Landscape Consultation Response

Application Ref: **PL/2025/09623**

Site Address: **Land off High Street, Sutton Benger, Wiltshire**

Development Proposal: **Application for the Approval of Reserved Matters (Appearance, Landscaping, Layout and Scale) for the Erection of 60 Dwellings, Public Open Space, Landscaping and Associated Infrastructure following Outline Planning Permission PL/2023/06204.**

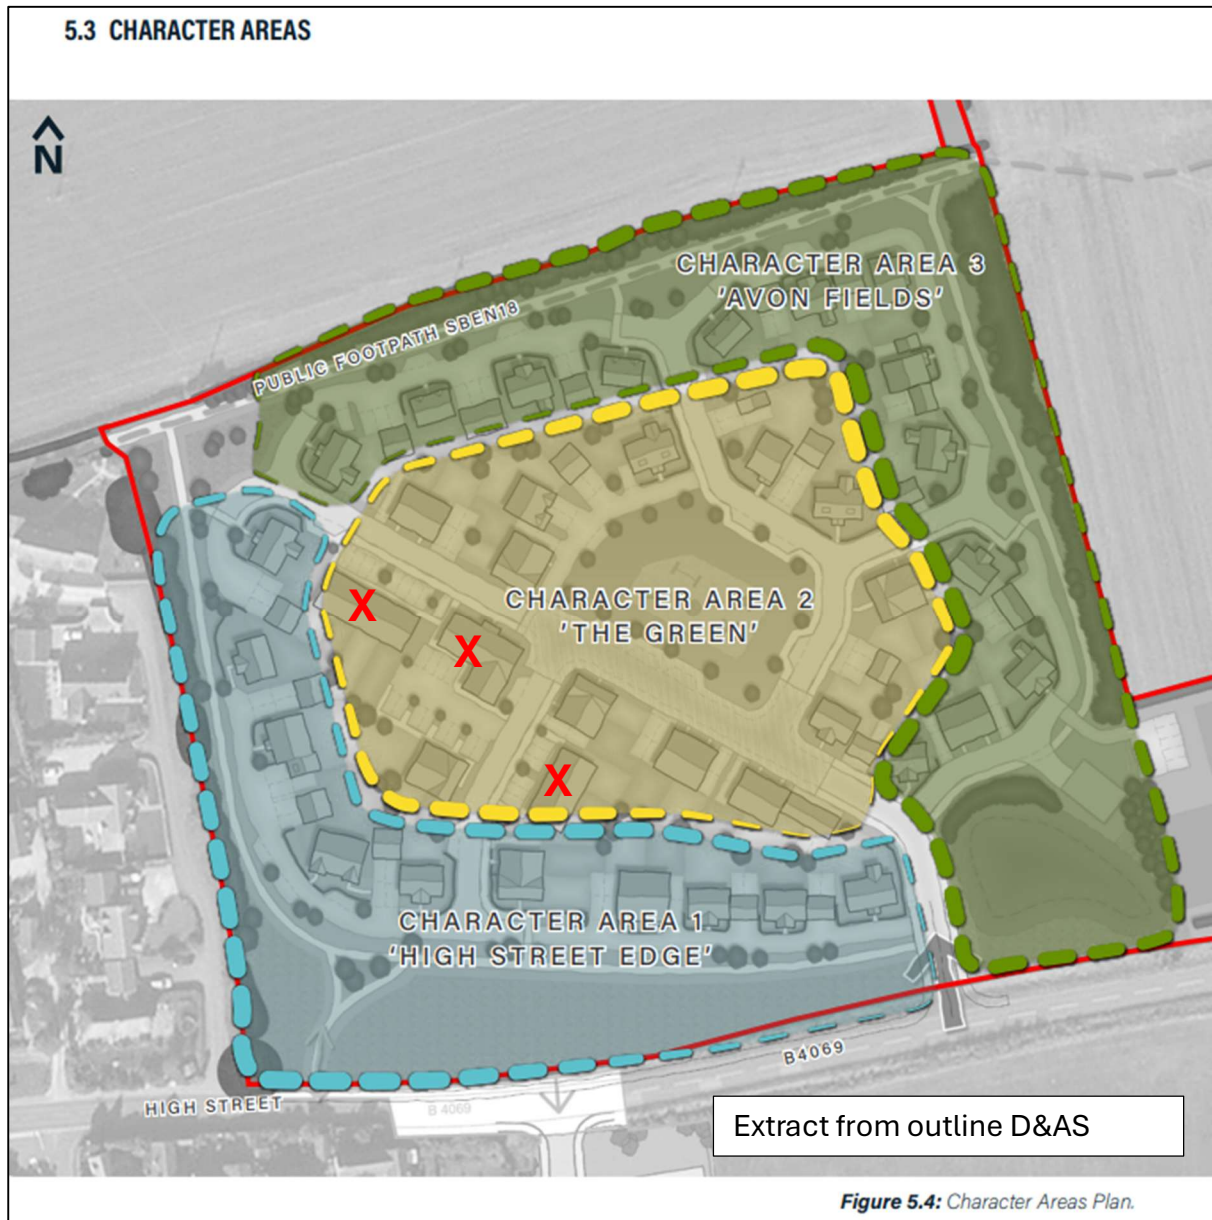
3. Garden sizes

- Plot 44 doesn't appear to have any amenity garden space.
- The rear garden of Plot 26 is terrible shape, dominated by garage incursions.
- Rear garden of Plot 39 appears to be unacceptably small.
